**Tightening torques and angle of rotation for cylinder head bolts on cold engine**

To obtain a more uniform and higher initial bolt preload, the cylinder head bolts with cylindrical shank (A) used up to now on engine 617.950 have been replaced by necked-down cylinder head bolts (B) starting February 1979. On engines 617.951/952, they are installed from start of series.

- A Hex. socket cylinder head bolt
- B Double hex. socket cylinder head bolt

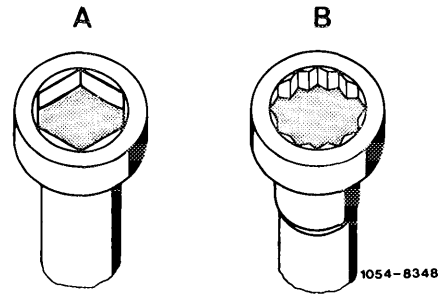
These cylinder head bolts have a reduced shank section (arrow) and longer threads.

In installed condition, the cylinder head bolts are identified by the double hex. socket (B), formerly hex. socket (A).

Cylinder head gasket part no. 617 016 05 20.

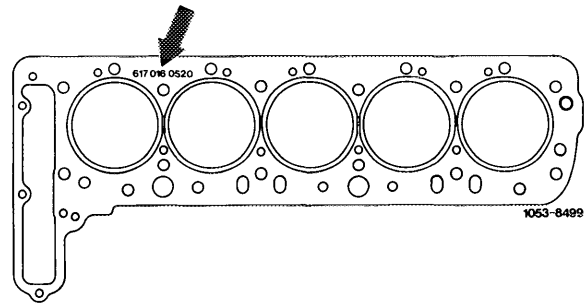
The cylinder head gasket has been simultaneously provided with an improved impregnation and the washers have been made harder.

The cylinder head gasket is identified by the impressed part no., the washers by the olive-colored chromate surface.

In the event of repairs on engines with double hex. socket cylinder head bolts only the cylinder head gasket with improved impregnation and harder washers may be installed.

On engine 617.950 with hex. socket cylinder head bolts, the cylinder head gasket with improved impregnation and harder washers may also be installed.

#### Dimensions of cylinder head bolts

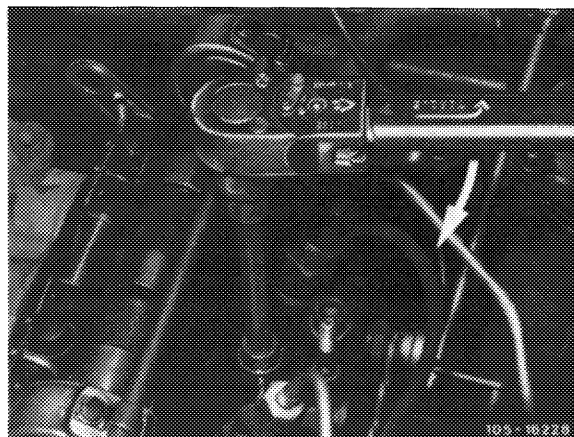
Since these cylinder head bolts are subject to a permanent elongation upon tightening, they must be replaced as soon as the max. longitudinal dimensions shown in table below are exceeded.

Owing to the permanent elongation, the threaded bores in cylinder crankcase have been made longer and the cylinder head bolts have been shortened by 1 mm.

For this reason, they must not be installed in engine 617.950 with hex. socket cylinder head bolts.

Always use the cylinder bolt version of removed engine.

It is also not permitted to install mixed cylinder head bolts on one and the same engine.
